Serial No. NA3-08-079R
Docket No. 52-017
COL/LTB

DOMINION VIRGINIA POWER
NORTH ANNA UNIT 3 COMBINED LICENSE APPLICATION
RESPONSE TO REQUEST FOR ADDITIONAL INFORMATION REGARDING THE
ENVIRONMENTAL REVIEW

On June 18, 2008, NRC requested additional information to support the review of certain portions of the North Anna Unit 3 Combined License Application (COLA). The responses to the following RAIs are provided as enclosures to this letter:

RAI ER Section 2.4-3 Enclosure 3 - Figure 1 Ladysmith Transmission Line and Habitat

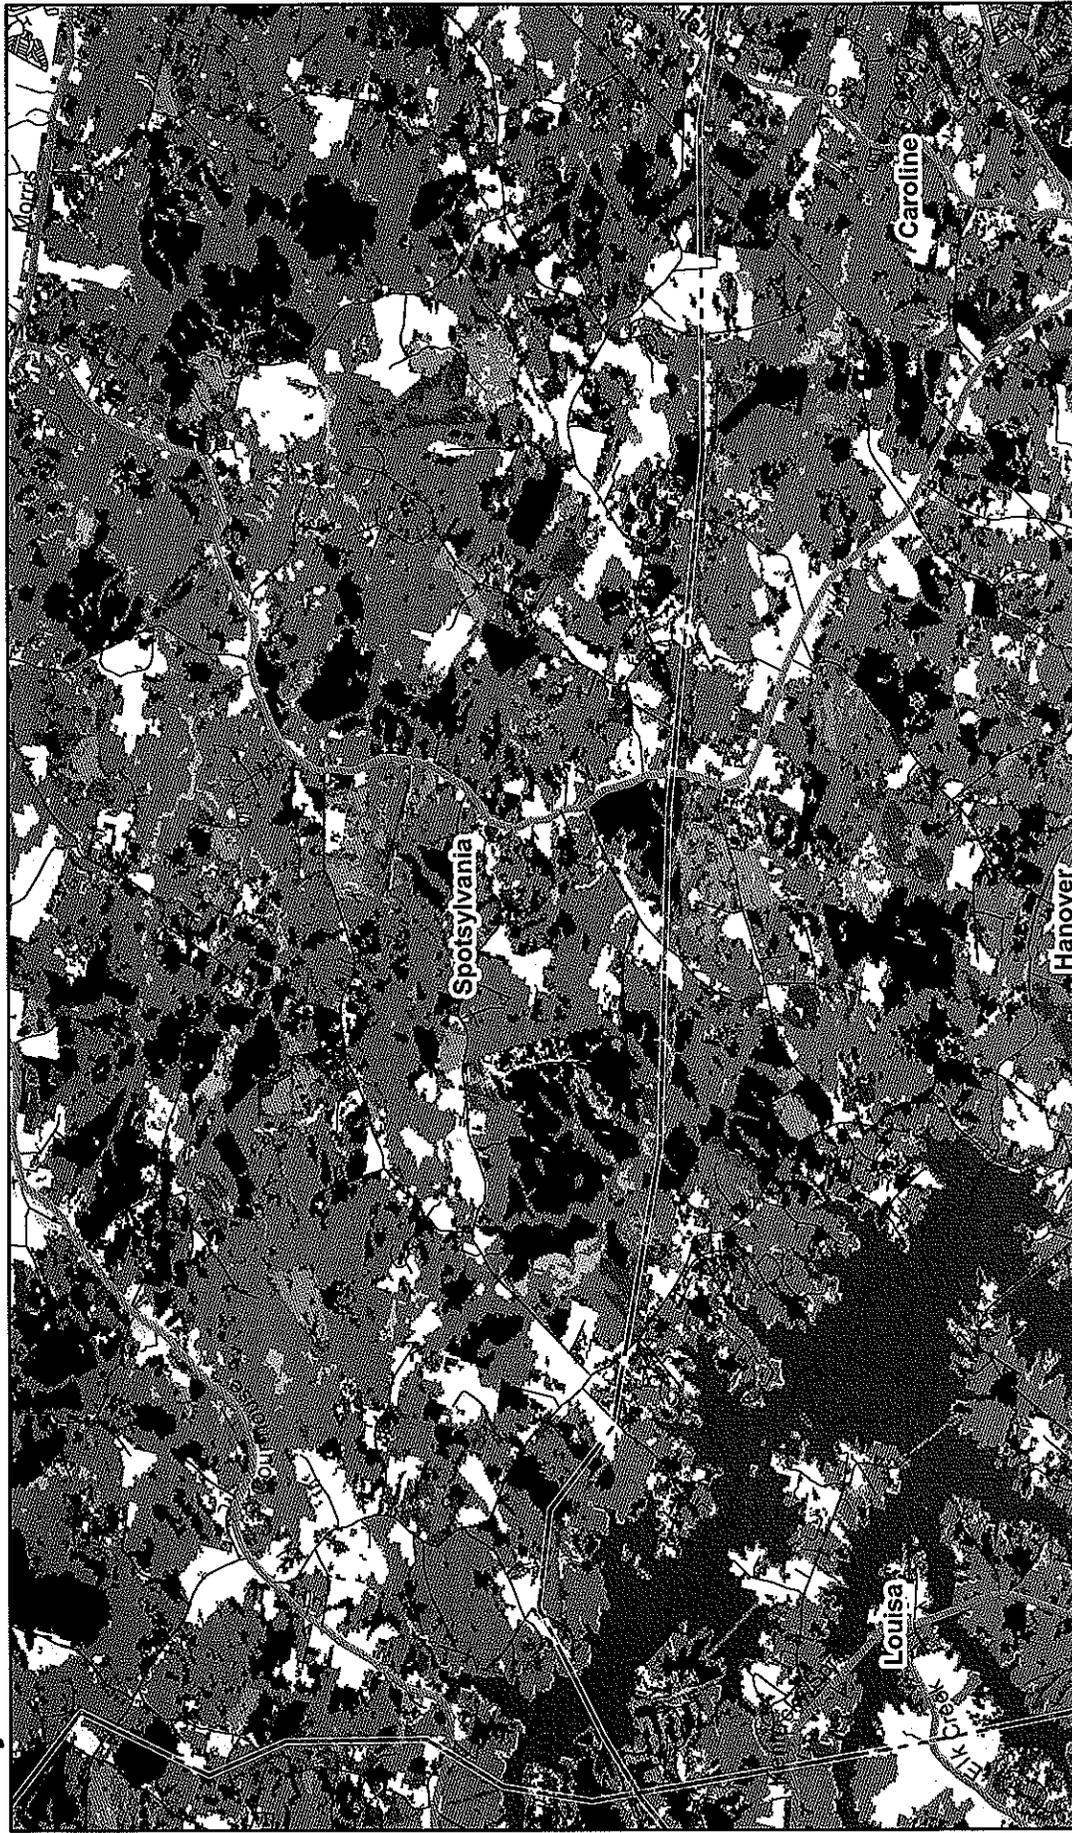
Provide a map of the habitat types along the Ladysmith transmission corridor, and the proportion (in percent) of each habitat type along the right-of-way.

A habitat map of the Ladysmith corridor is provided in Figure 1 of this enclosure. The background habitat mosaic of Figures 1 and 2 was created from the National Land Cover Dataset (NLCD). (See Dominion response to RAI Question ER Section 2.4-1 for additional information regarding NLCD.) The NLCD codes were used for mapping habitat types and to develop the enclosed figure. The corridor is 275 feet wide. The percent habitats that occur within 150 feet of either side of the centerline of the corridor are provided below (for a total width of 300 feet, or 25 feet wider than the corridor), and code definitions follow that.

SCHEMATIC ARRANGEMENT OF NAPS UNIT 3 MAKE-UP WATER PUMP INTAKE
RAI ER Section 3.4-1 Figure 1a

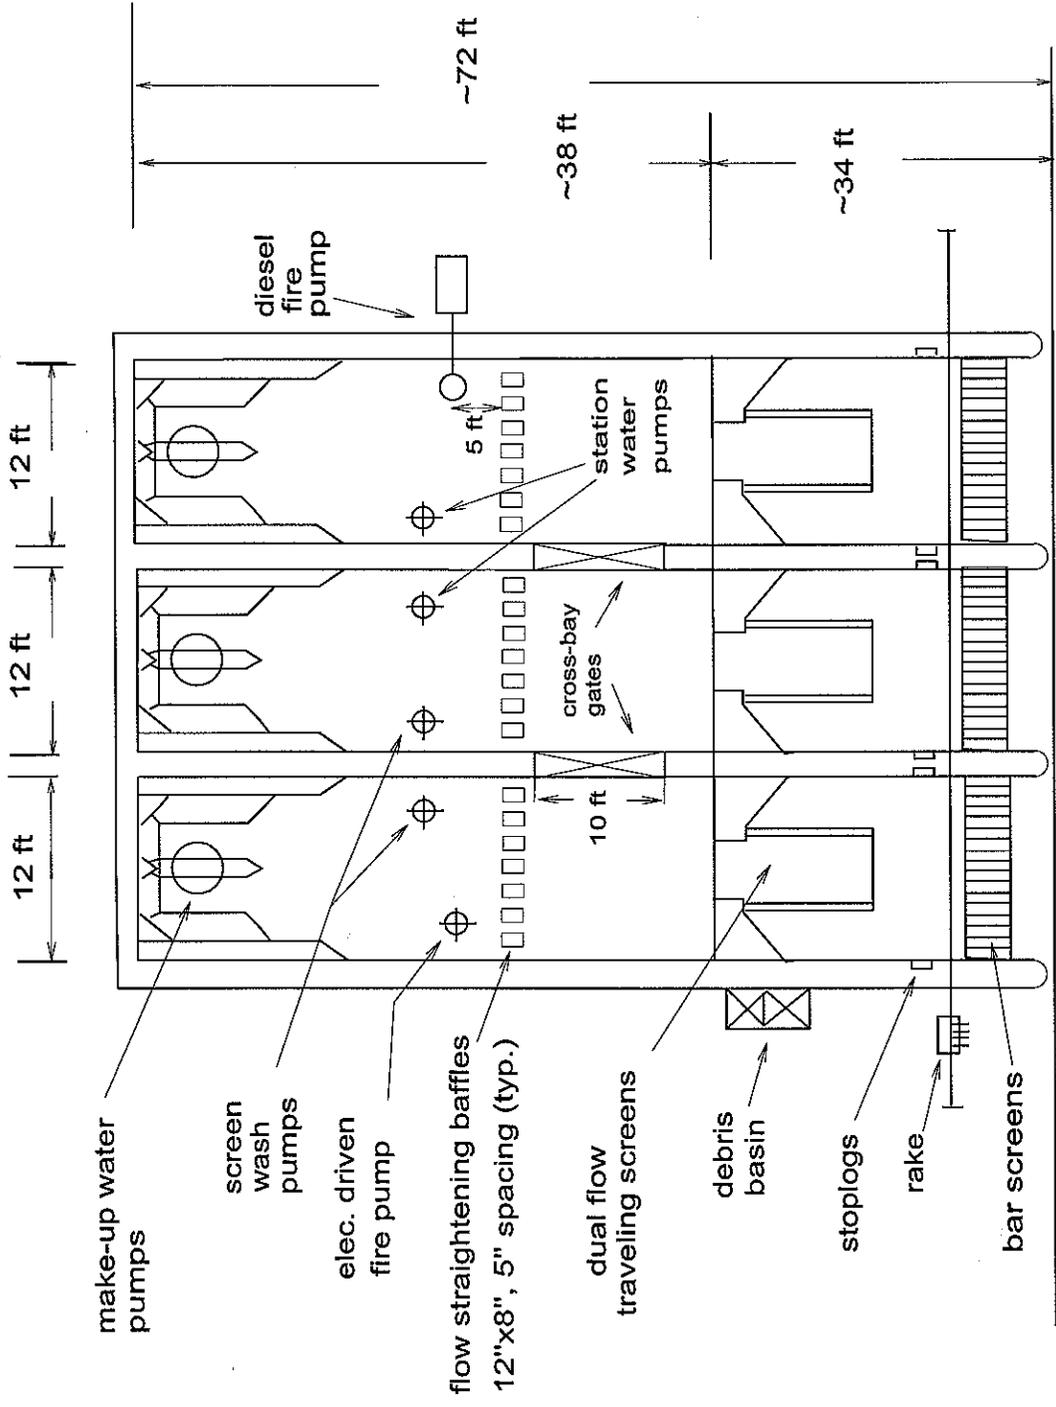
ER Section 3.4-1: To the extent information is available describe the Unit 3 Intake design, including the lagoon and any culverts through the coffer dam, and the new intake structure dimensions, the design flow velocity, the fish screens, and other features. Provide updated figures of the intake area (plan view), the planned intake structure, and flow path.

The Unit 3 intake structure withdraws water from Lake Anna to supply the plant's water needs. It has three pump/screen bays and is designed to accommodate the following combination of pumps:

To protect the pumps from debris, the entrance opening of the intake structure is equipped with trash racks and raking mechanism. Downstream of the trash racks, there are three sets of dual flow traveling water screens, each with an 8-ft basket width and a 2 mm screen mesh size. The maximum flow-through velocity at the openings of the trash racks and the traveling water screens is designed to be less than 0.5 ft/sec. Figures 1a and 1b are schematic sketches that illustrate the principal hydraulic dimensions of the intake structure. Minor adjustments of the intake dimensions are expected to be necessary during detailed design stage to accommodate the size of equipment (pumps and screens) specified by the suppliers.

RAI ER Section 2.4-1 Enclosure 1 - Figure 1
 Construction Footprint and Habitat

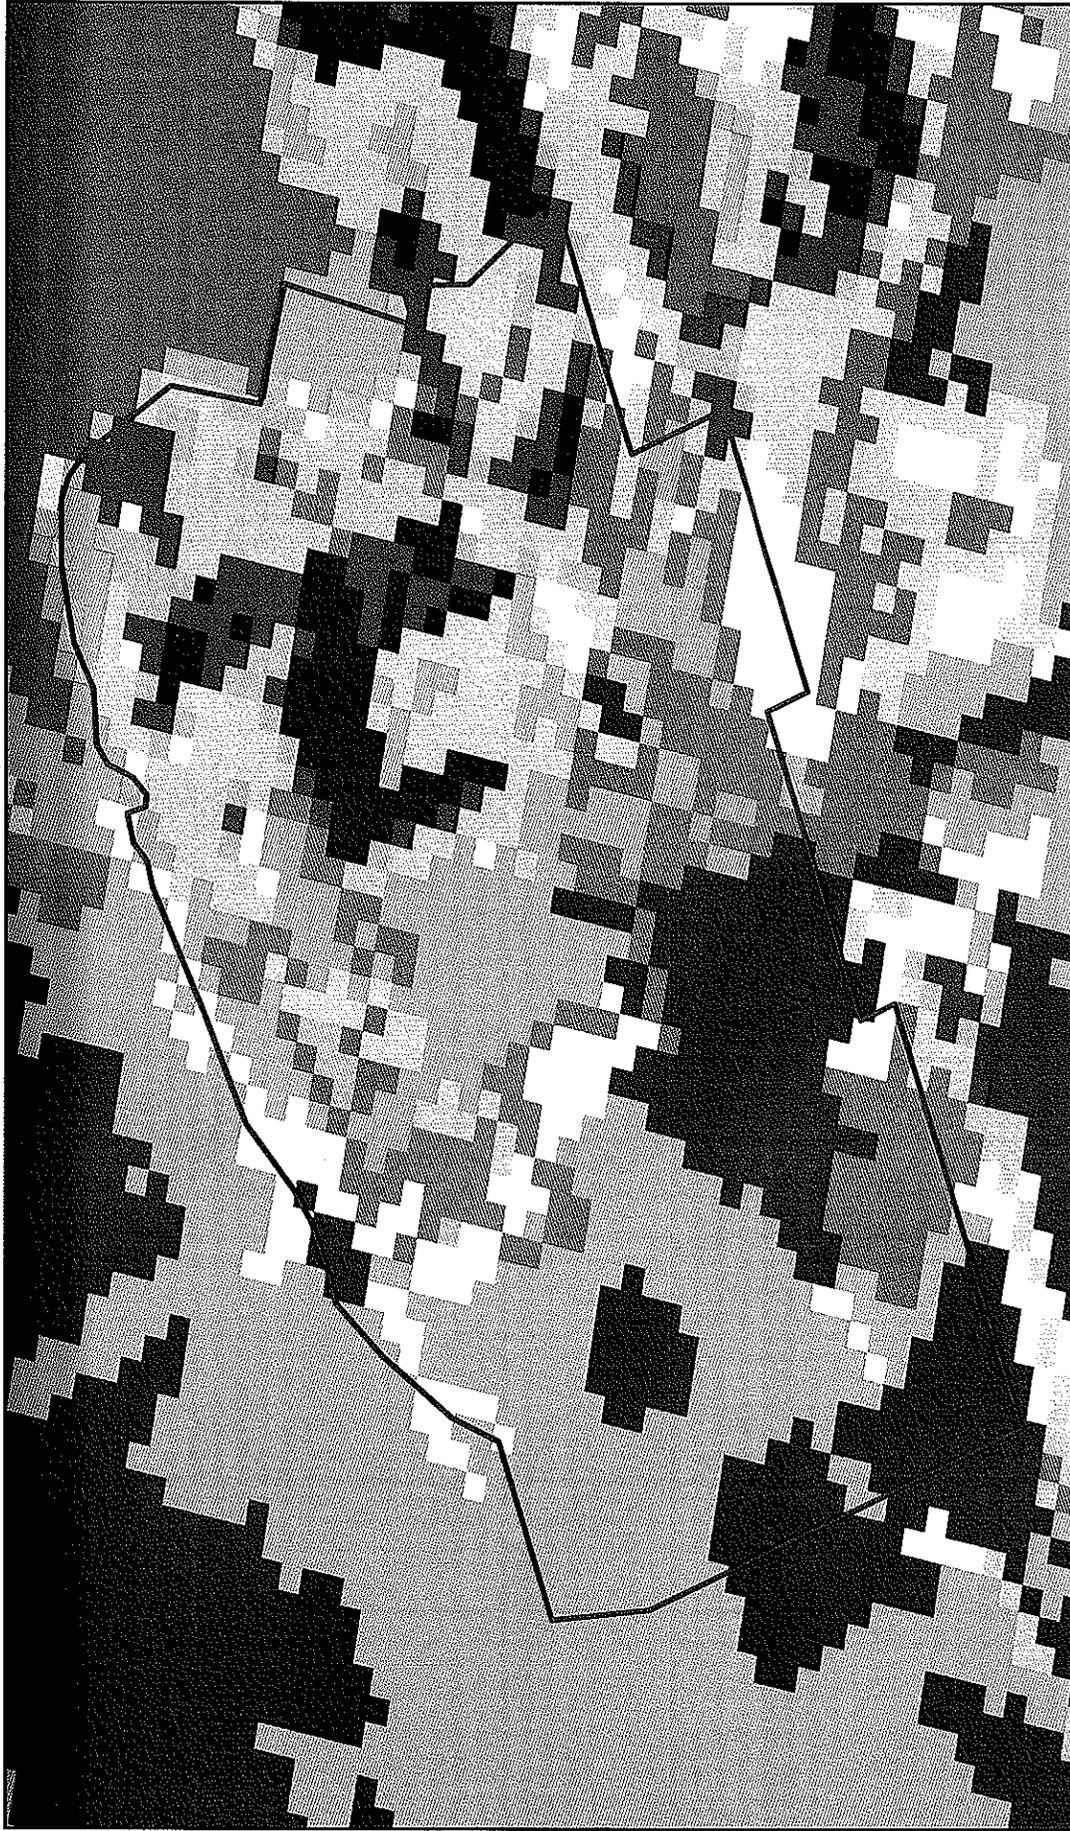
Provide updated accounting of habitat types within the construction footprint, the total size of the footprint, and the number of acres of each habitat type within the footprint. Describe the proportion that will be permanently and temporarily impacted by habitat type. Provide an overlay of the construction footprint on a habitat map of the site.

A habitat map of this area is provided as Figure 1 of this enclosure. Figure 2 of this enclosure provides an overlay of this area on a habitat map of the site.

RAI ER Section 4.1-1 Figure 2

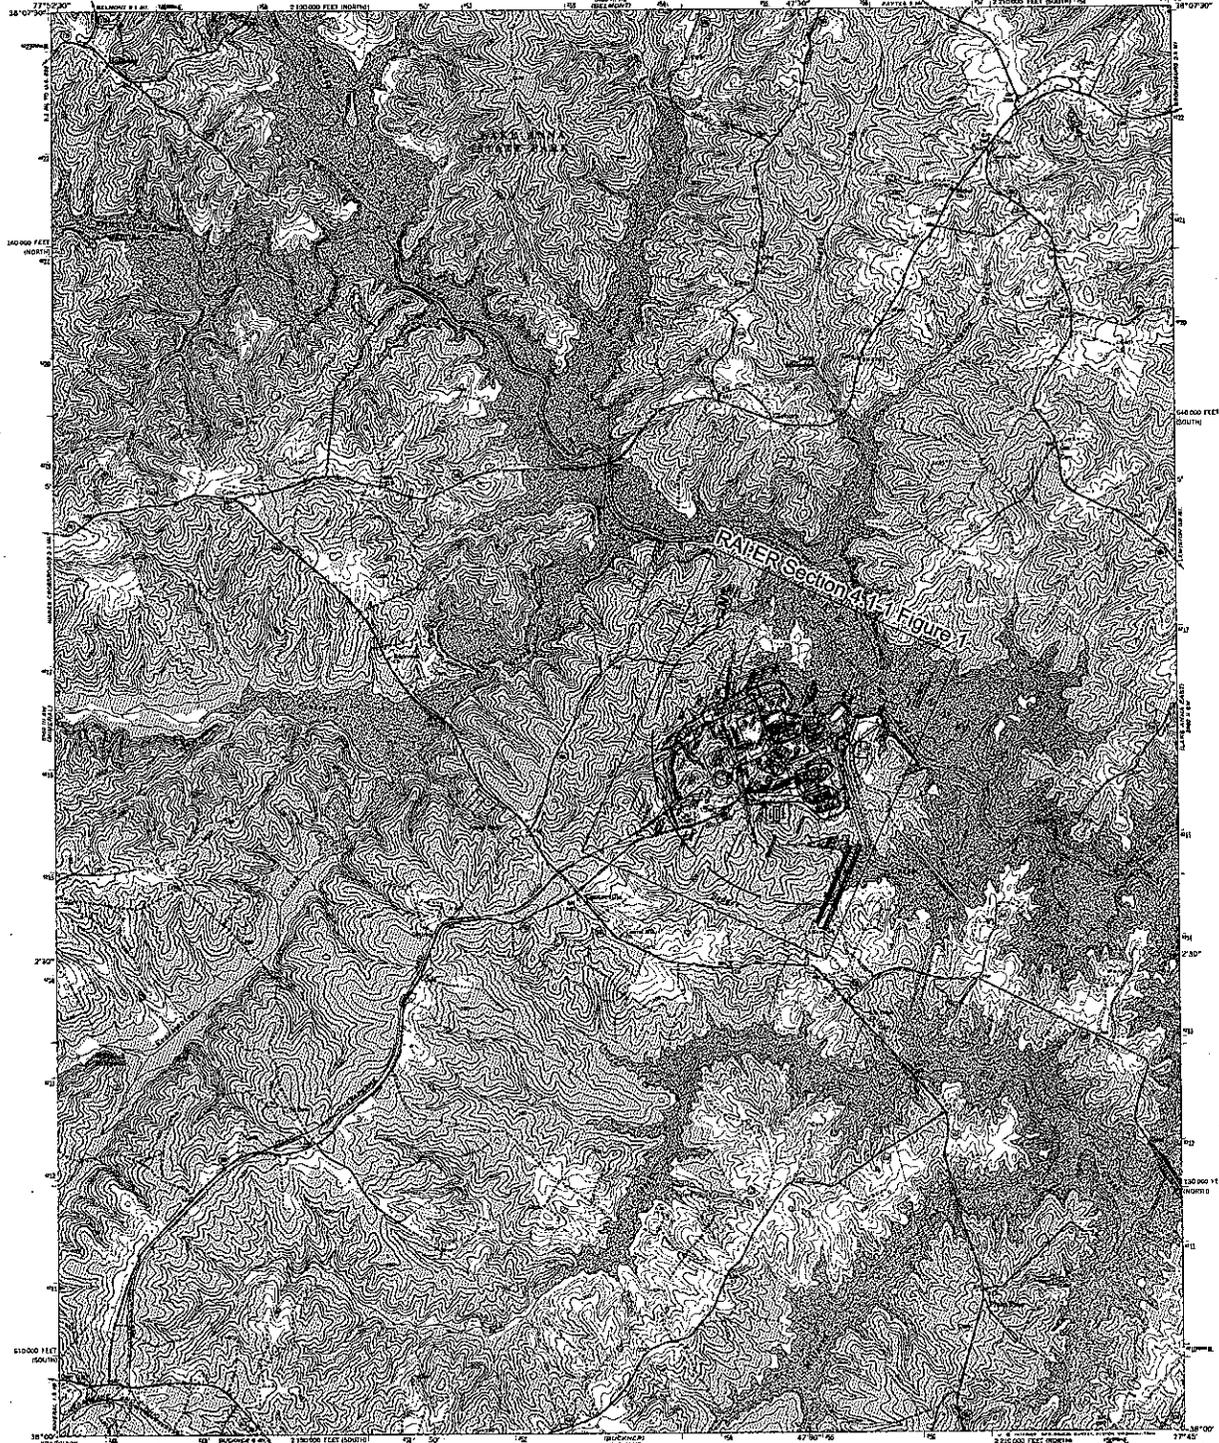
Provide a USGS 7.5 minute map with construction boundaries (including lay down areas) and cultural survey areas.

The enclosed two figures provide the information requested. Figure 1 is a “zoom-in” of the North Anna site overlaid on a USGS contour map, fit to better show construction and cultural resources areas. Figure 2 is the full 7.5 minute USGS Lake Anna West Quadrangle map with the Figure 1 overlay. Please note that the “construction boundaries” shown on this figure only delimit the on-site areas that will be used for Unit 3 facilities and construction support facilities and activities, and do not include (1) areas that may be impacted as a result of additions and modifications to facilities supporting Units 1 and 2, (2) the NAPS-to-Ladysmith transmission corridor, and (3) [
